**Letter to Industry**  
**LTI#. 0000023**

**Summary of Issue/Topic:** Blowoffs with drainage holes should not be allowed in areas subject to high groundwater, flooding, containment or pollution spills, or areas where surface water ponds.

CITY OF MANASSAS, VIRGINIA  
 DEPARTMENT OF PUBLIC WORKS

## BLOWOFF DETAIL

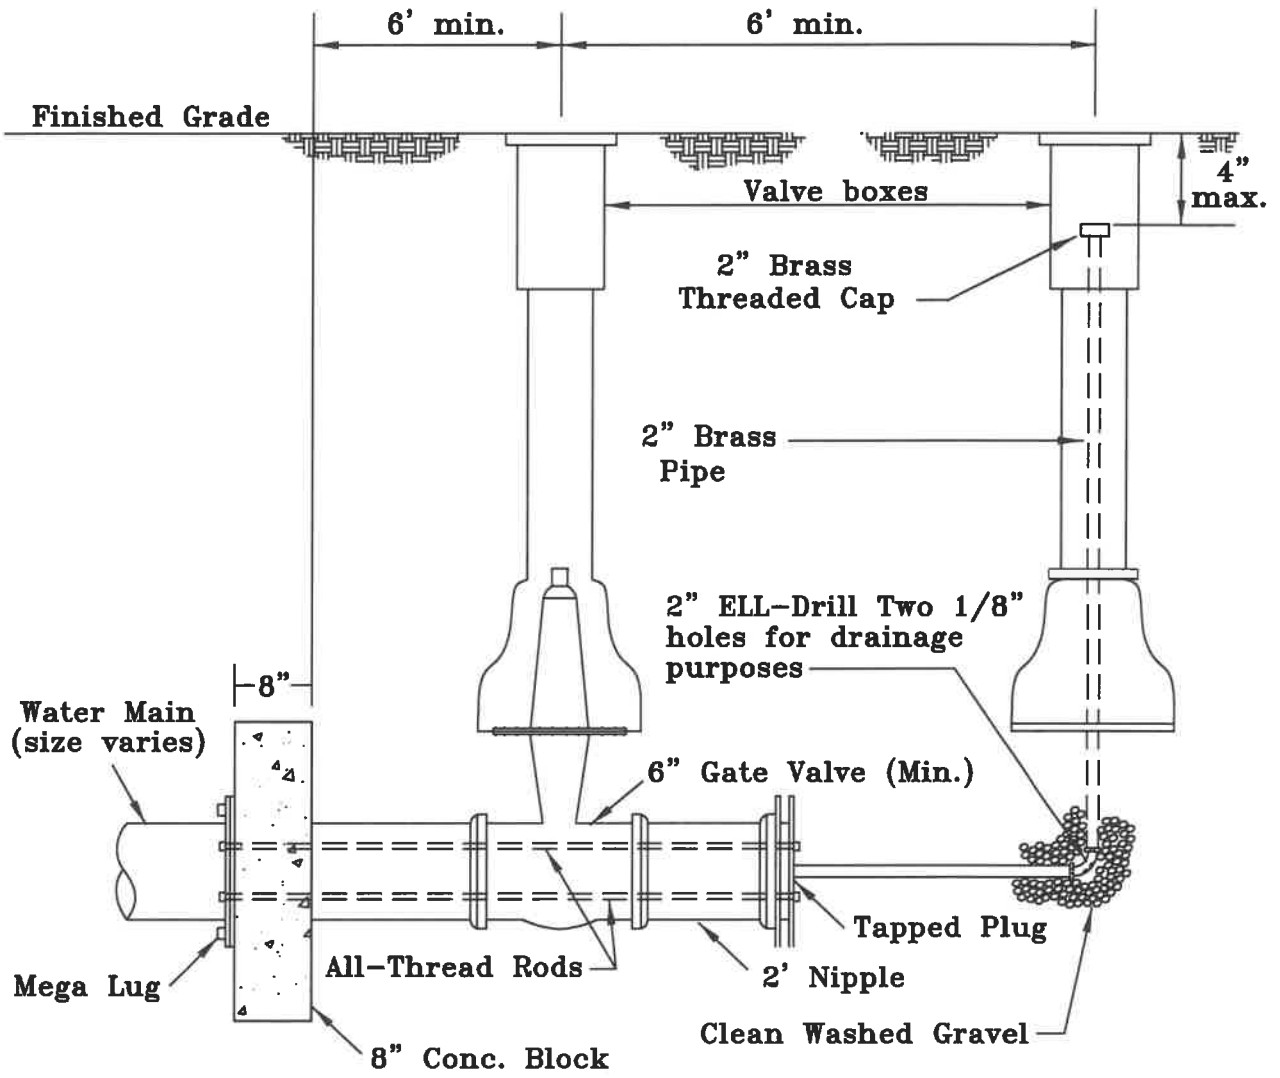
**Policy/  
Design  
Requirements/  
Guidelines:** Replace existing Detail W-5.0 with the attached Detail W-5.0

**Background:** These changes are required to comply with Title 32.1 of the *Code of Virginia* and 12VAC5-590 *et seq.* of the *Virginia Waterworks Regulations*. The Virginia Department of Health (VDH) requires to provide a note on the detail that blowoffs with drainage holes should not be allowed in areas subject to high groundwater, flooding, containment or pollution spills, or areas where surface water ponds. Detail changes address this requirement.

- NOTES:**
1. All 2" pipe and fittings shall be brass.
  2. Shall be located within the roadway.
  3. Shall not be located in areas subject to high groundwater, flooding, containment or pollution spills, or areas where surface water ponds.
